Zeus Pod TVM Software Change

All Zeus 3000 series pod drives

Situation

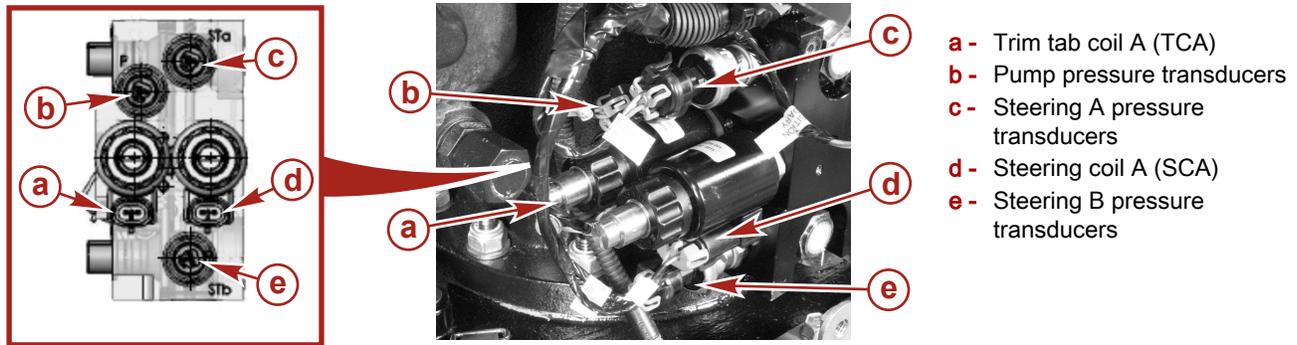
After the reflash process is complete, verify that the TVM calibration matches the SC 2.5 module as shown in the screenshot below.

42111

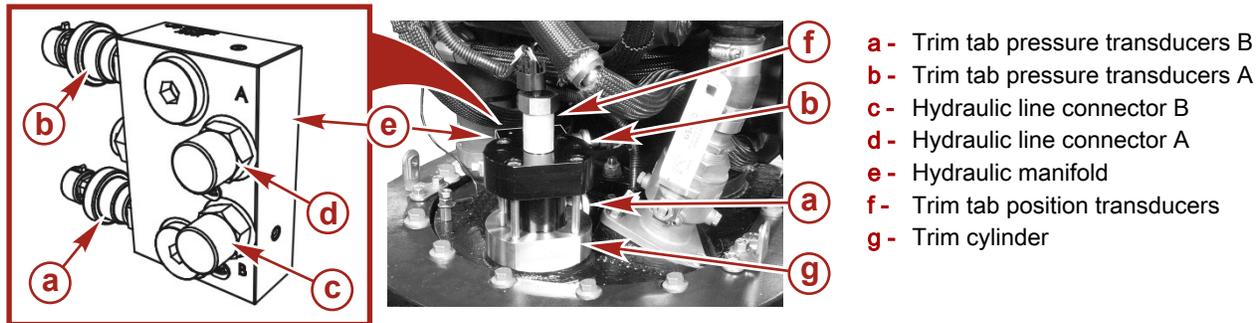
Each pod's hydraulic trim tab manifold contains two pressure transducers. These trim tab pressure transducers are identified by the letters a and b in the following illustration.

NOTE: Ensure that the sensor fitting and the area around the sensor are clean before removal to avoid contamination. Use only a lint-free cloth to clean the sensor area before removal. The replacement sensor must remain sealed in the shipping container until time of installation.

Qty.	Description	Nm	lb-in.	lb-ft	Part Number
1	Hydraulic pressure transducer kit	25	—	18	8M0078384

Steering manifold

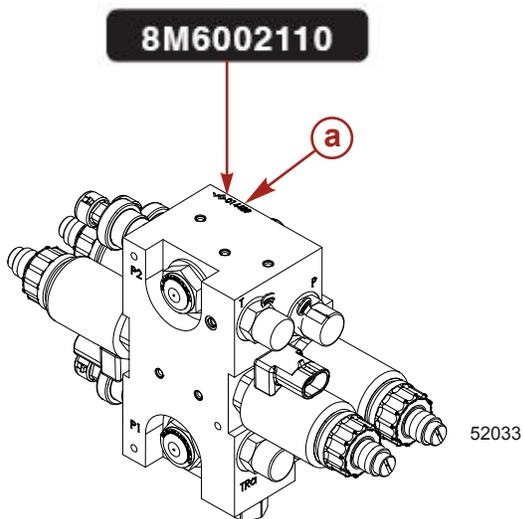
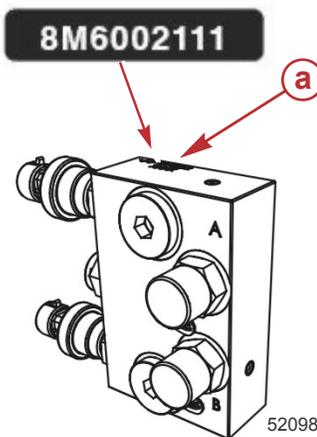
Two decal labels are included in the transducer kit. The labels should be installed on the steering manifold and the trim manifold. Use the following illustrations to determine the placement of each label. These labels indicate that the newer 3500 psi pressure transducers have been installed for future part replacement reference. Ensure that the surface is clean, dry, and free of oil prior to the application of the decal.

a - Affix the decal here
